Subject: Rampion 2. Pl 20045105

Comparison of two Potential Substation Sites

Flooding at Oakendene - Proposed substation site

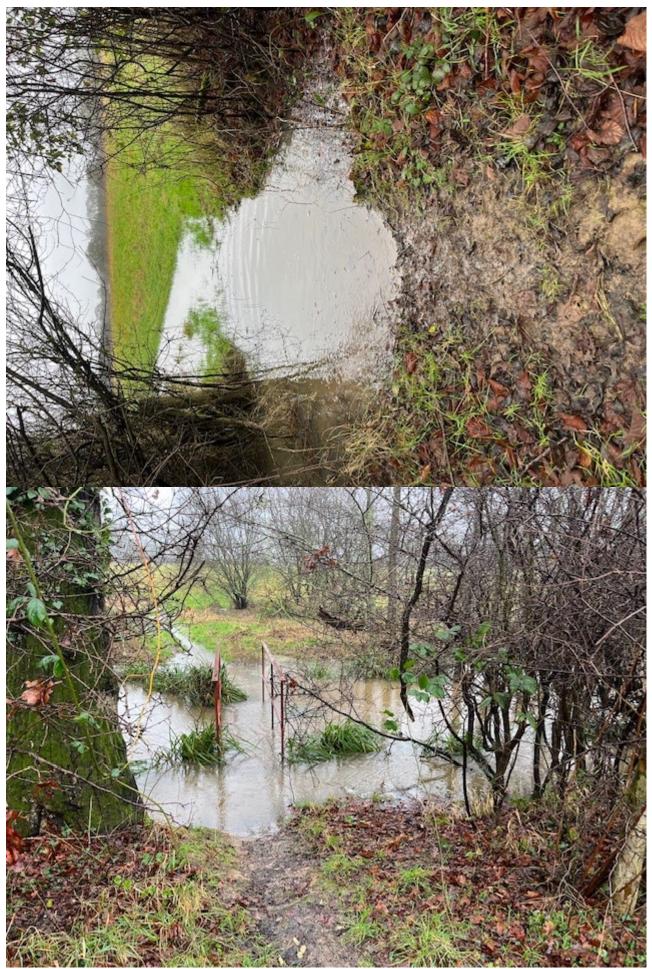
The first eight photos highlight extensive flooding in the fields at Oakendene, Cowfold, the proposed site for the substation. Heavy rainfall on the 4-/5- of February 2025 caused the fields to flood due to surface water runoff and the Cowfold Stream bursting its banks.

Under normal circumstances, the flooding at this site would have been far worse than shown in these photos. Surface water from north of the A272 is typically directed towards these fields. However, on this occasion, blocked culverts prevented some of the surface water from reaching Oakendene, instead causing flooding in fields north of the A272.

The local council has committed to clearing the culverts, which will read to more surface water from north of the A272 flowing directly into the Oakenedene site. The situation will likely deteriorate further when hundreds of trees and over 600m of hedgerows are removed, and the site is replaced with a concrete and steel base.

It is concerning that this flooding is not reflected in the outdated Environmental Agency flood maps used by Rampion. The Met Office has warned of worsening storms and prolonged rainfall due to climate change, which will exacerbate flooding risks in the area.

The flooding extends far beyond the end of the bridge and into the next field. The bridge was too dangerous to use.

The large oak trees in the centre of the photo is usually on dry land with the stream running to its left. However, all theentire area, including the trees in the foreground and to the right, is now flooded.
